Riverside Station

Response to Woodland Golf Club Comment Letter

June 19, 2020

Drawing Number

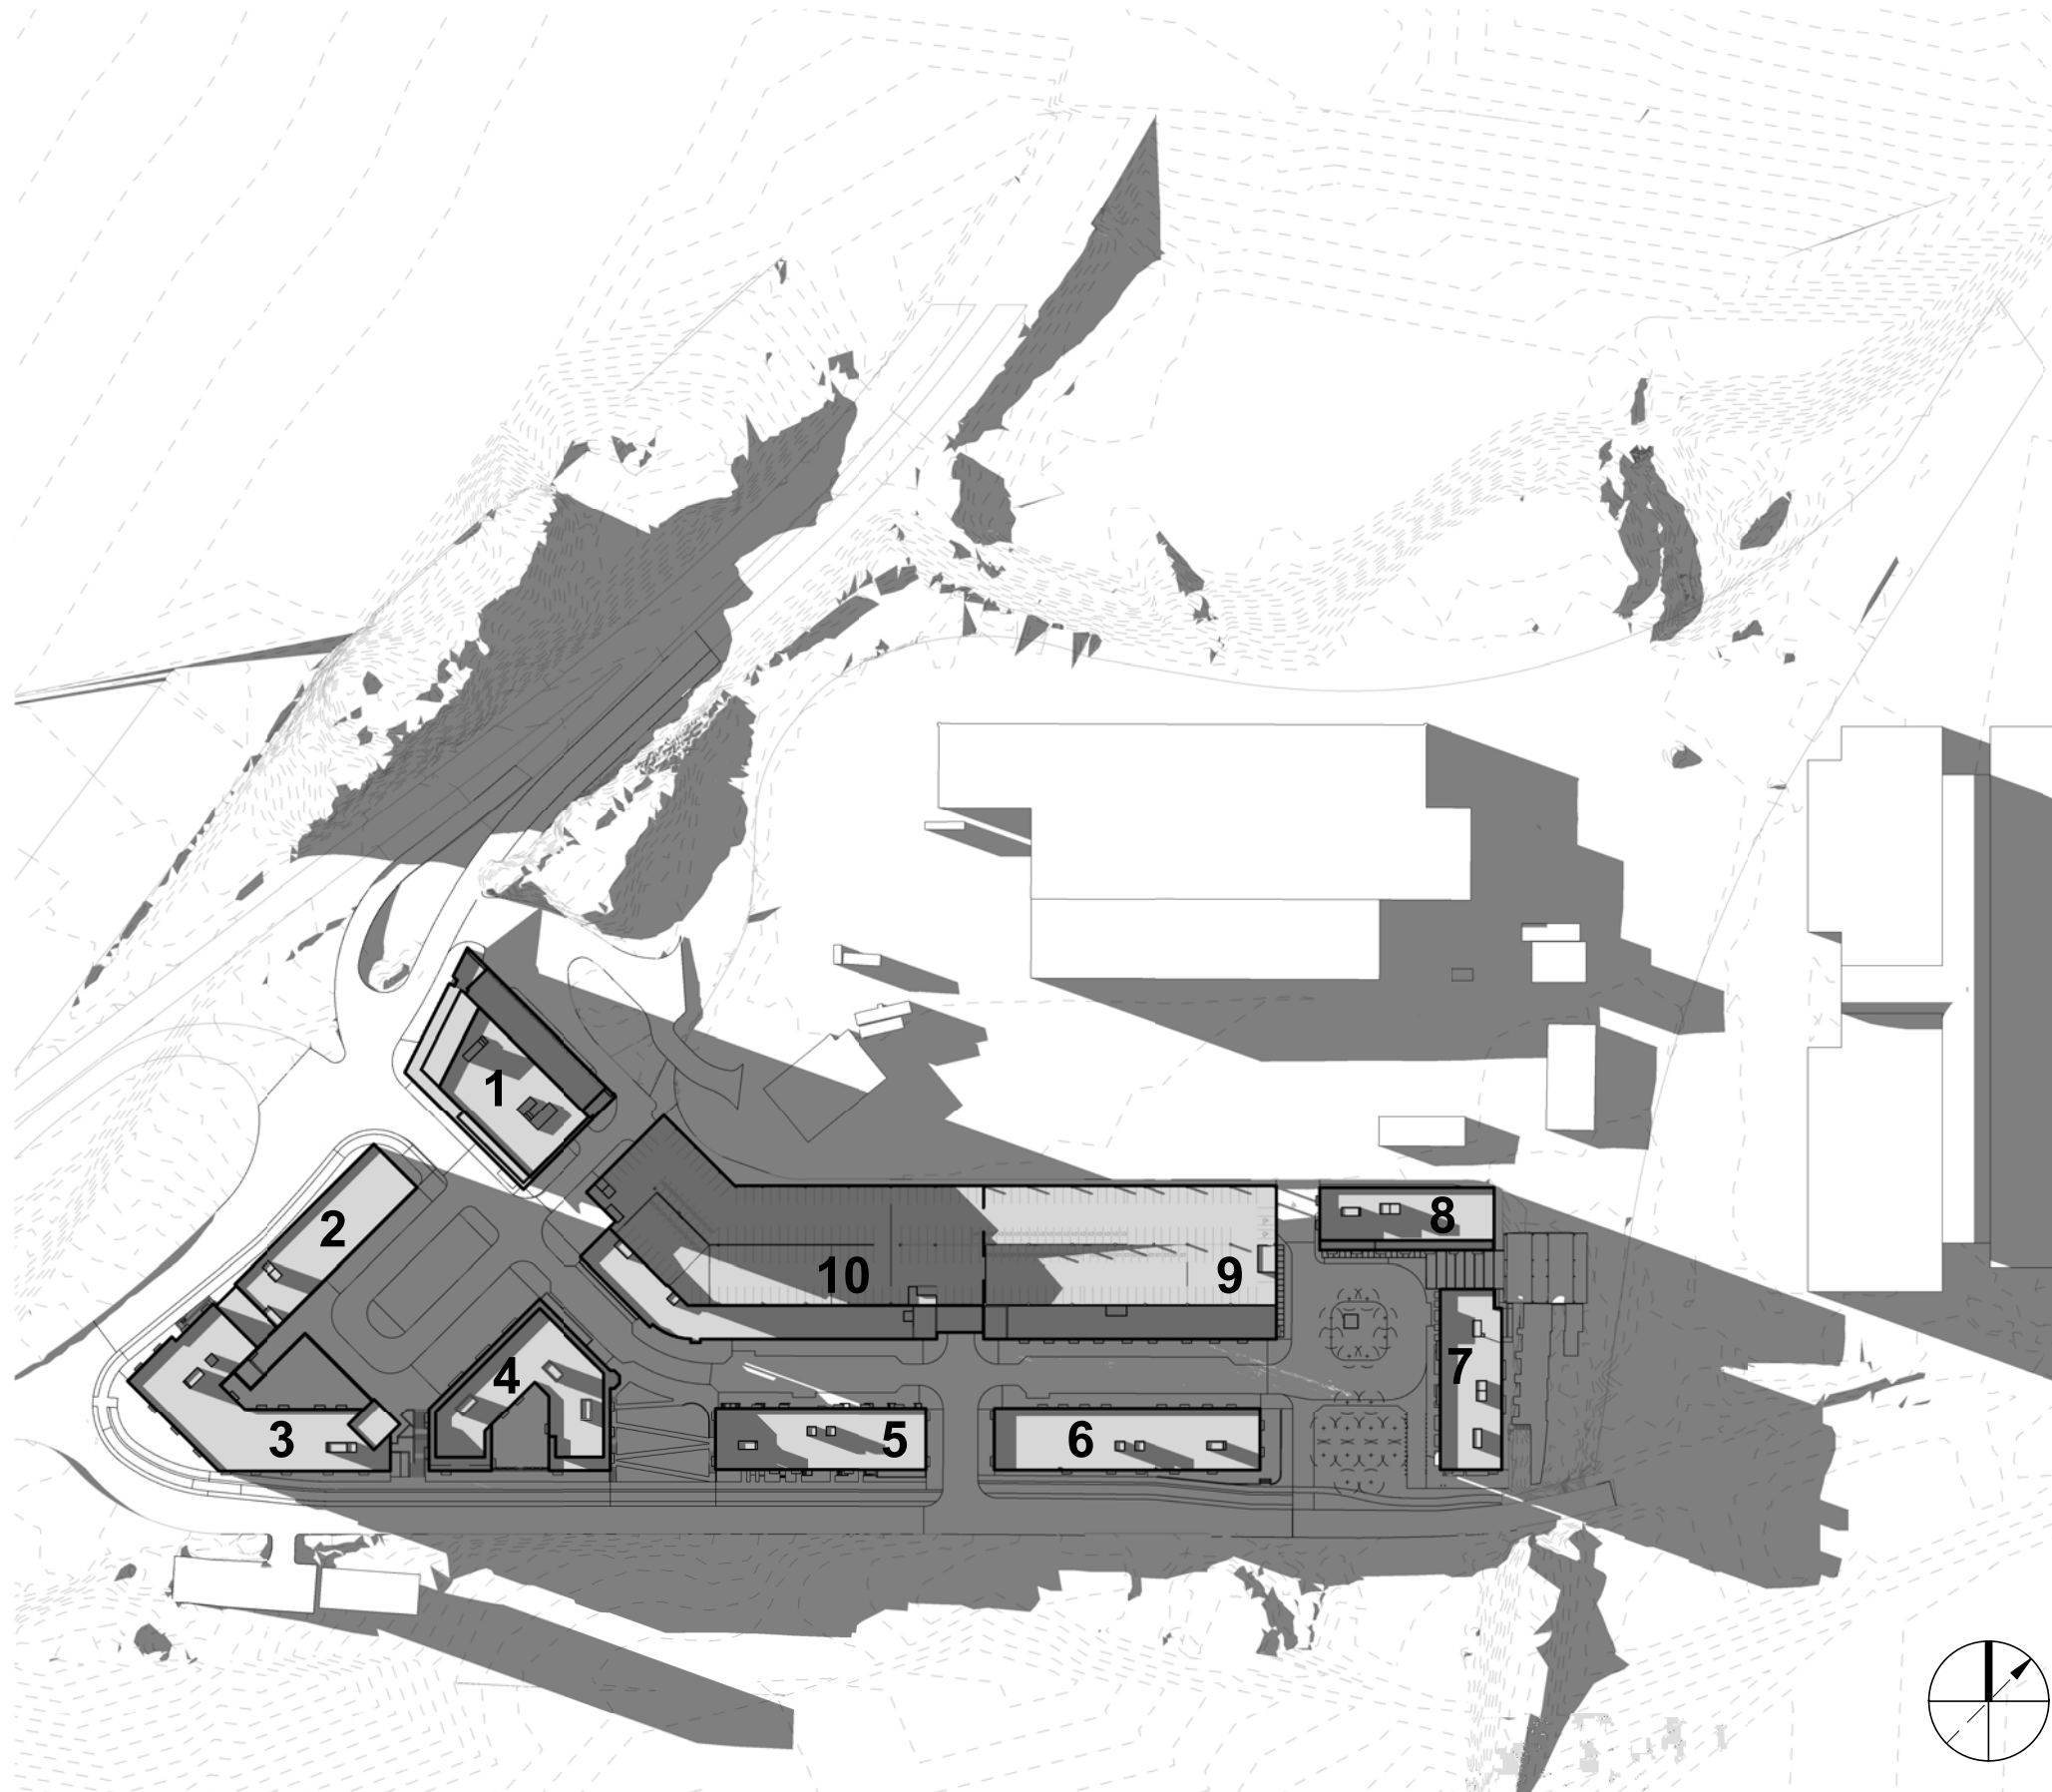
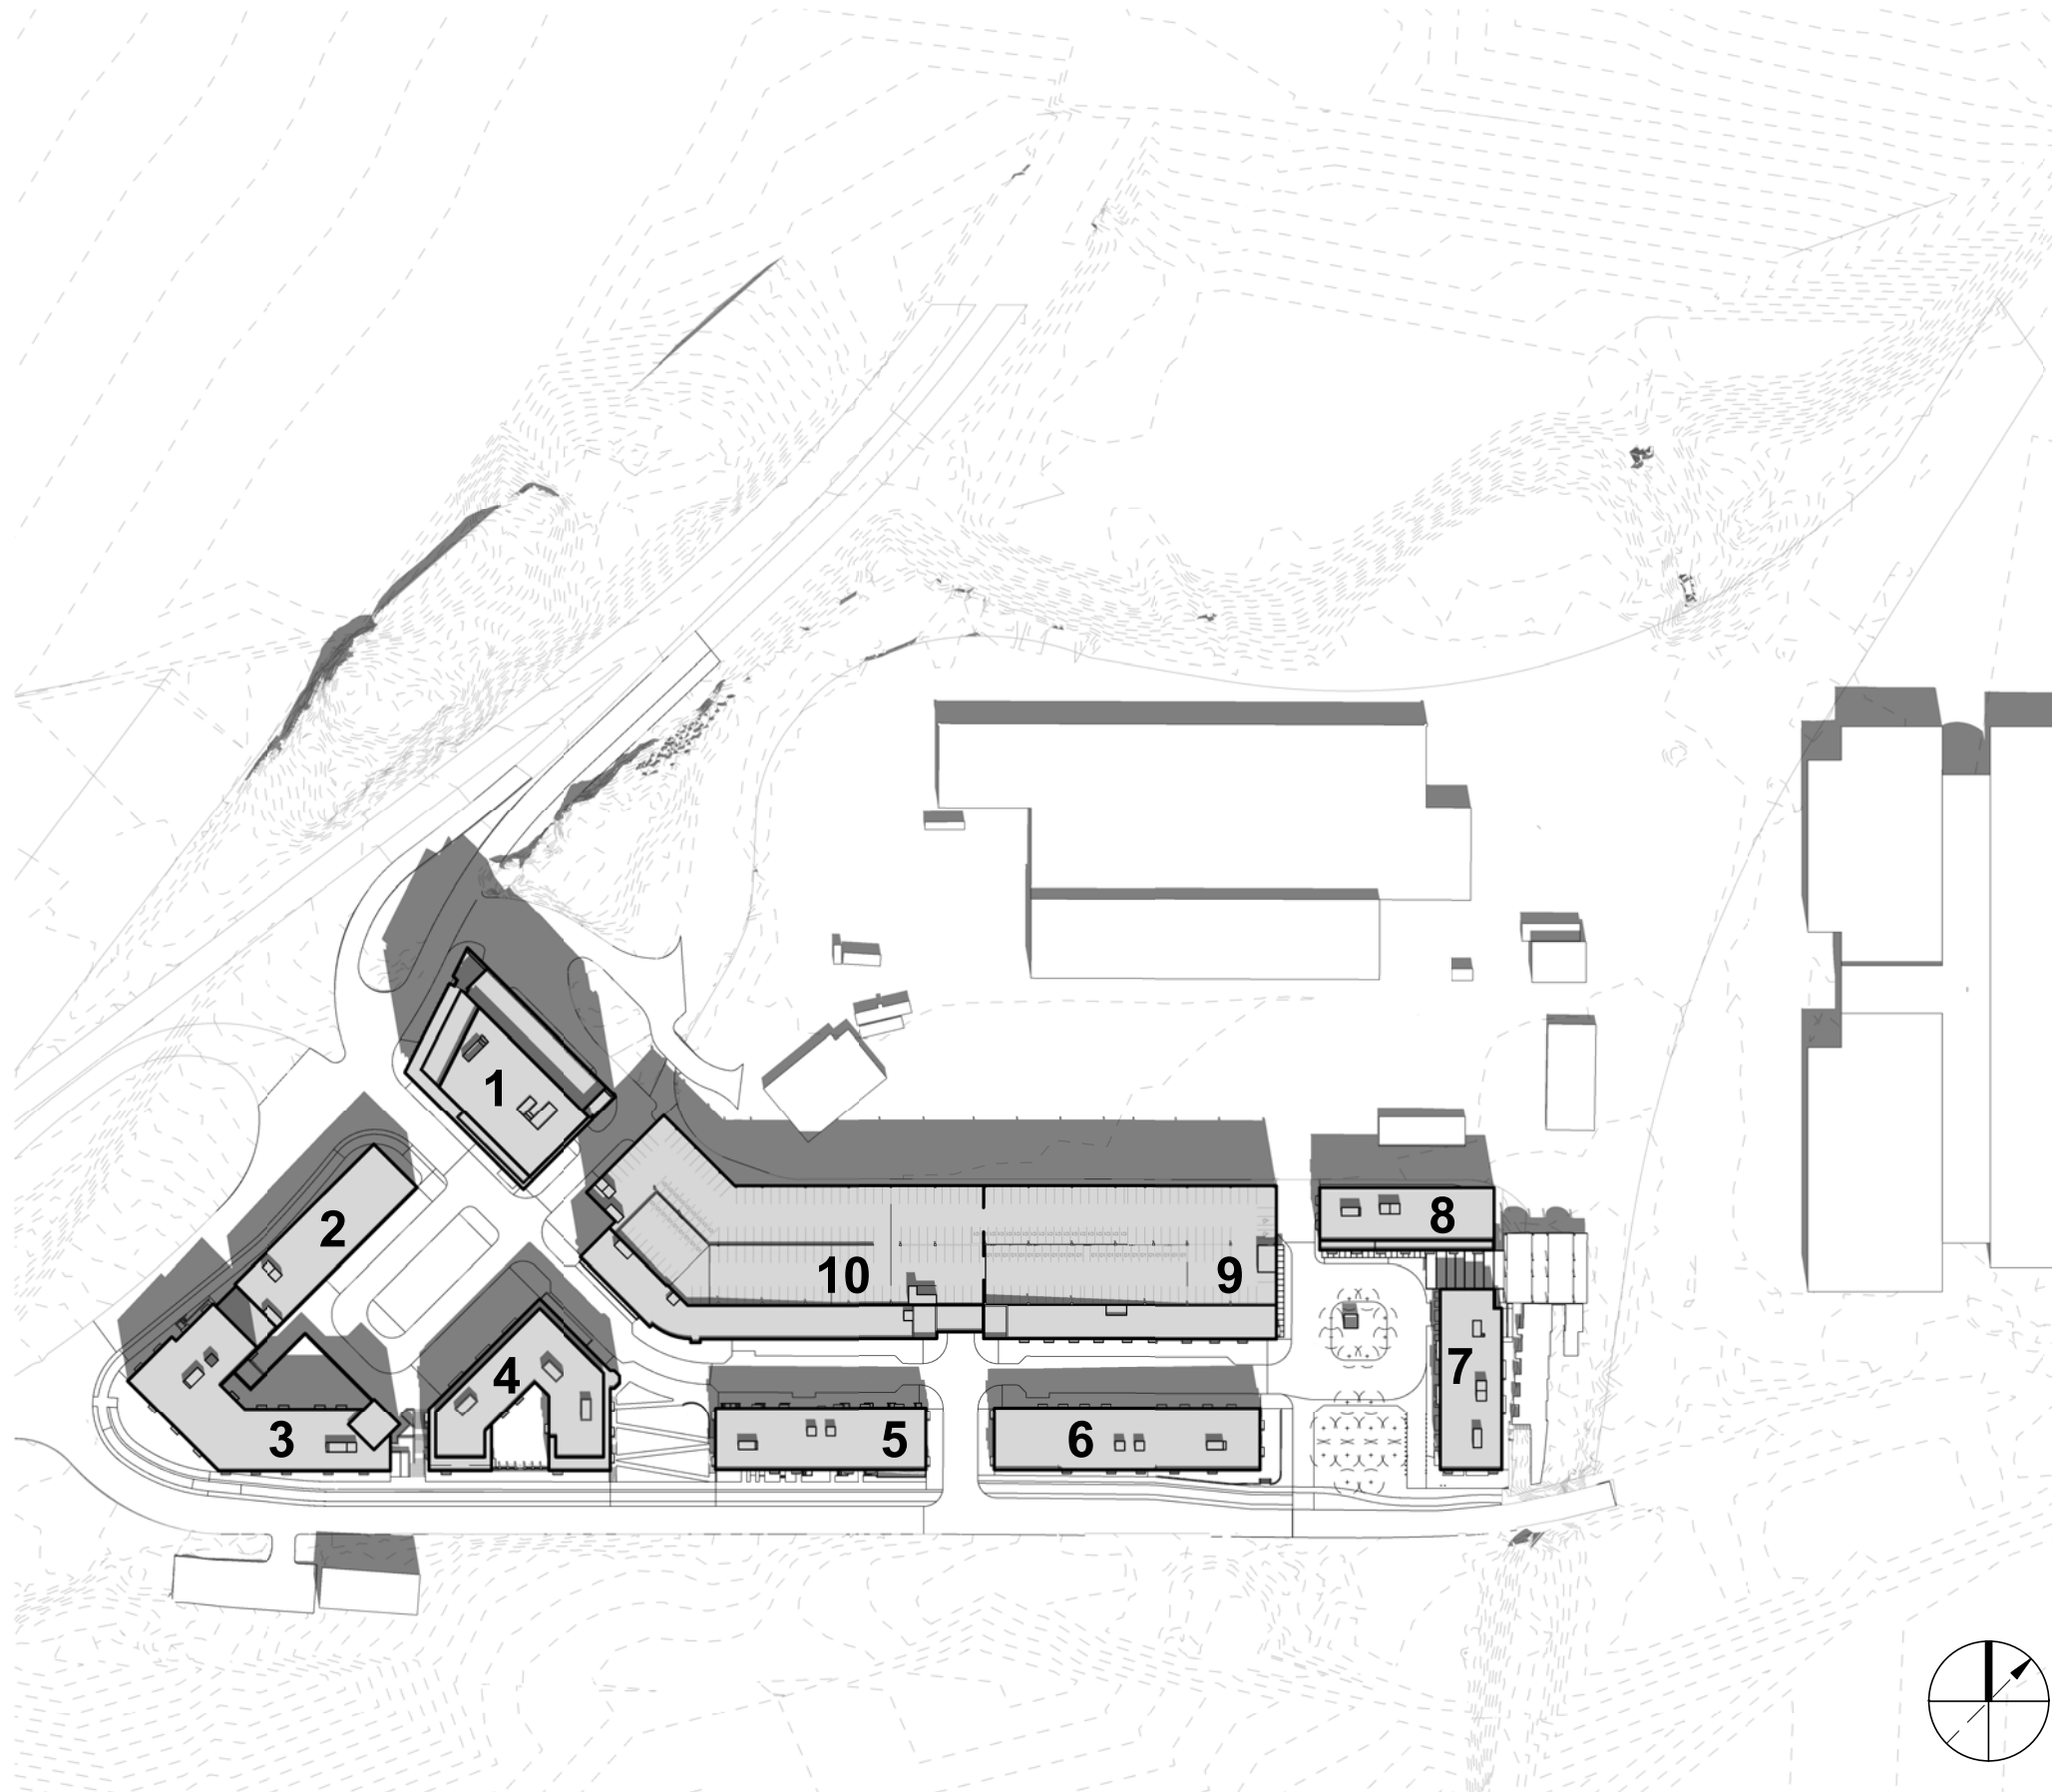
Woodland is also concerned that certain environmental impacts from the Project on the golf course have not been discussed nor has the mitigation of those impacts. Specifically, Woodland is concerned about the impact of shadows from the buildings on the greens, fairway, and related vegetation on the golf course. There does not appear to be any information on how the proposed buildings and their associated shadows may alter sunlight the golf course currently receives under the existing condition of parking lots on the Project site. The Applicant should address the impact of shadows on the greens, fairway, and vegetation on the golf course.

A shadow study has been included in the project plans on file. They are also attached for reference. This analysis concludes that during the Spring, Summer and Fall months, from 9AM to 3PM the project will not cast any shadows on the course. The shorter buildings along Grove Street will cast a slight shadow into the rough adjacent to the 5th hole at their peak on December 21st. This shadow is less impactful than that of the existing condominium. This slight shadow does not appear to approach the fairway, tee box, greens or cart paths in the event someone was on the course at this time of year, which is unlikely.
